RFI

RFI #: 128
 Date: 5/29/2012
 Job: EB-02 Keller Springs Lofts
 Phone: 877-777-5115

Subject: Corridor duct issues

Drawing: M3.1, M3@, A3.1C, A3.2C, A3.3C, A3.4C
 Cost Impact: None
 Spec Section: Schedule Impact: None

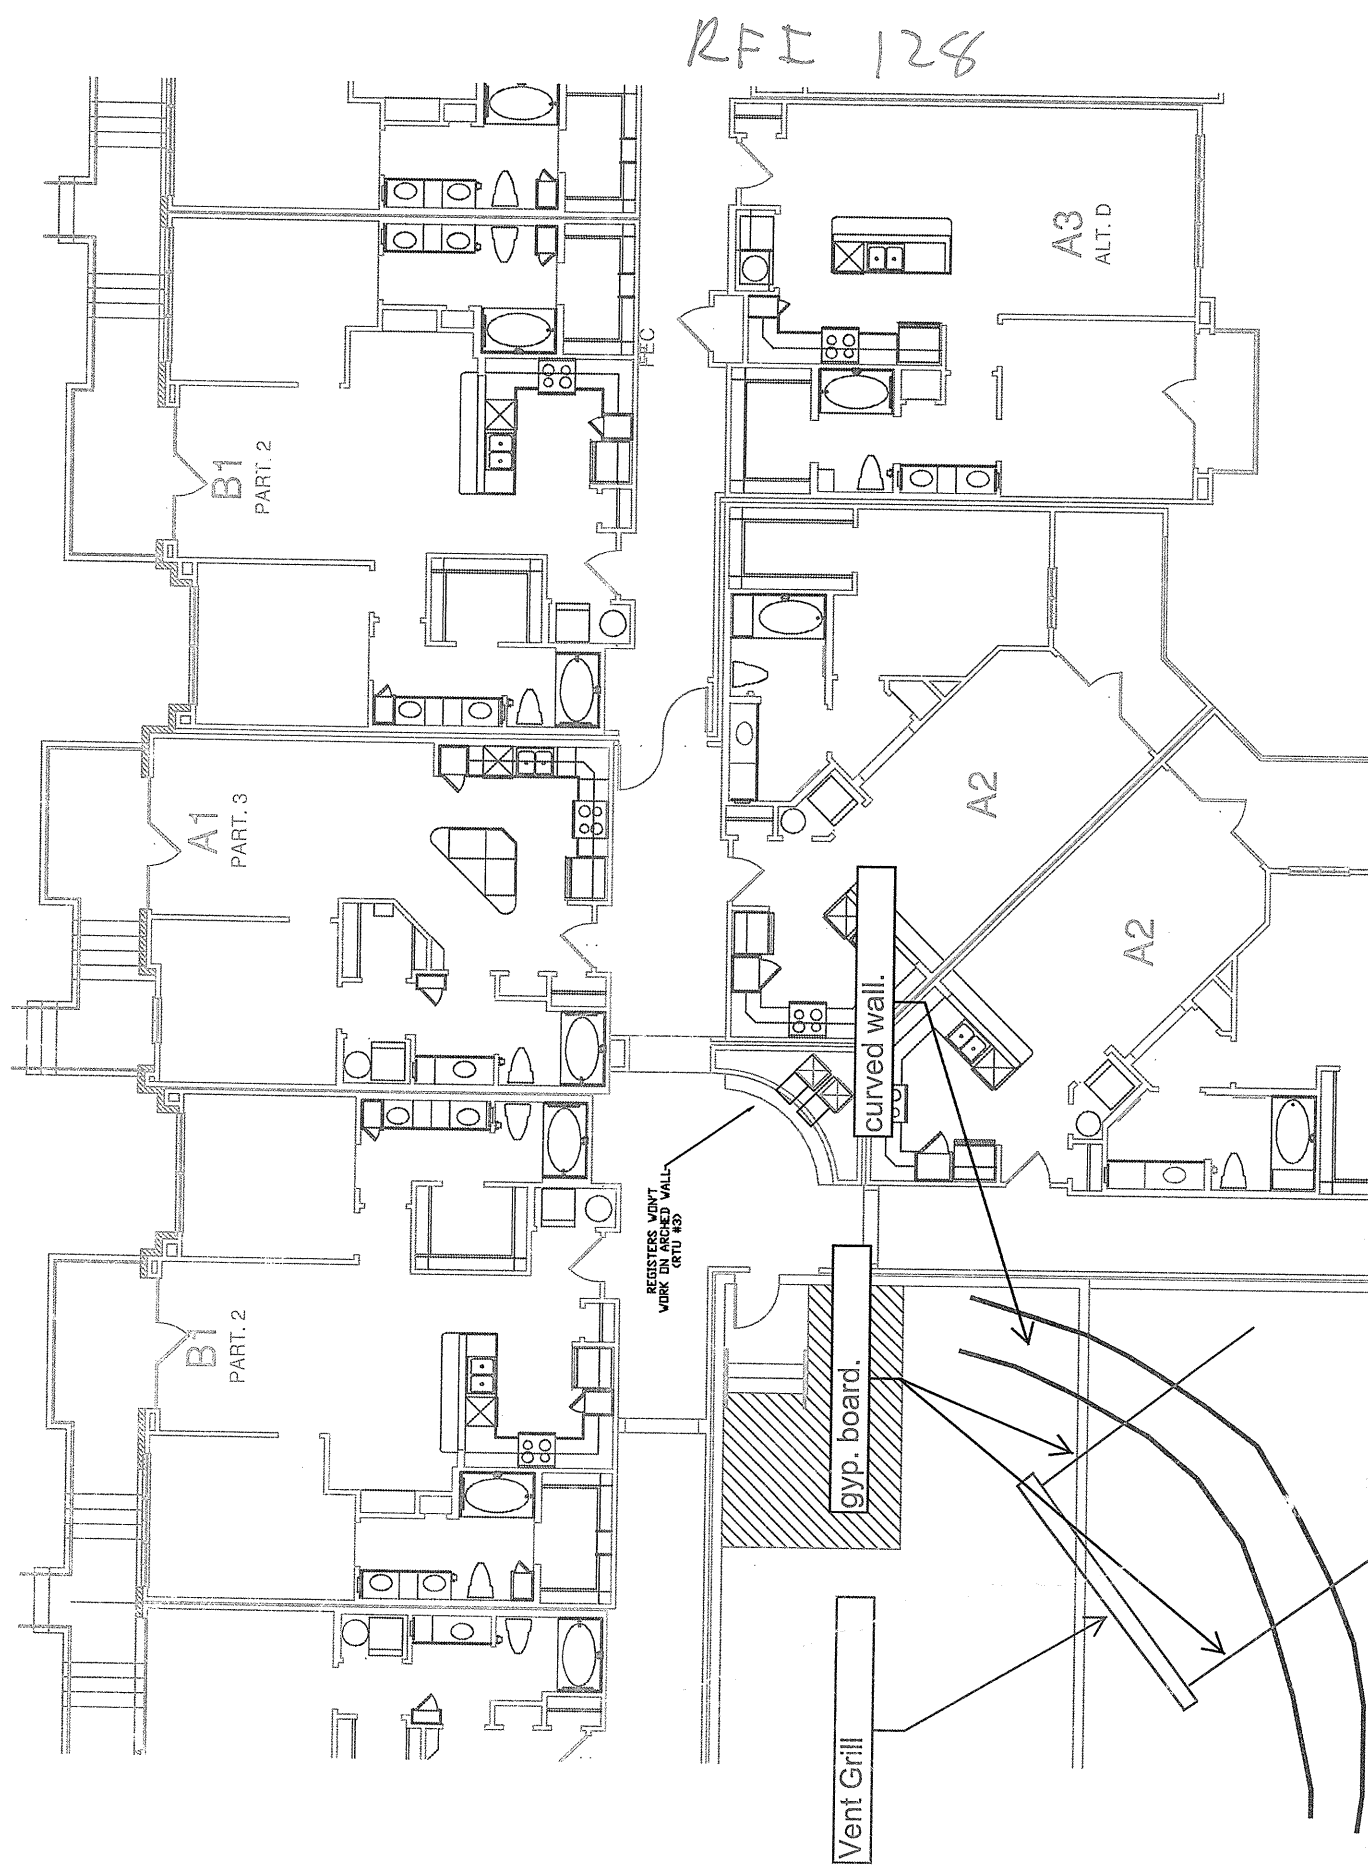
Request:
 The supply and return air grills will not work on the curved walls on each floor as shown on A3.1C, A3.2C, A3.3C and A3.4C. A portion of the wall will need to be straight for the grills.

Response:
 Based on correspondence between Ryan Faulds at BGO and David Miller with Embrey via email on Thursday July 12th, the walls will be updated to provide flat areas for the supply and return grilles.
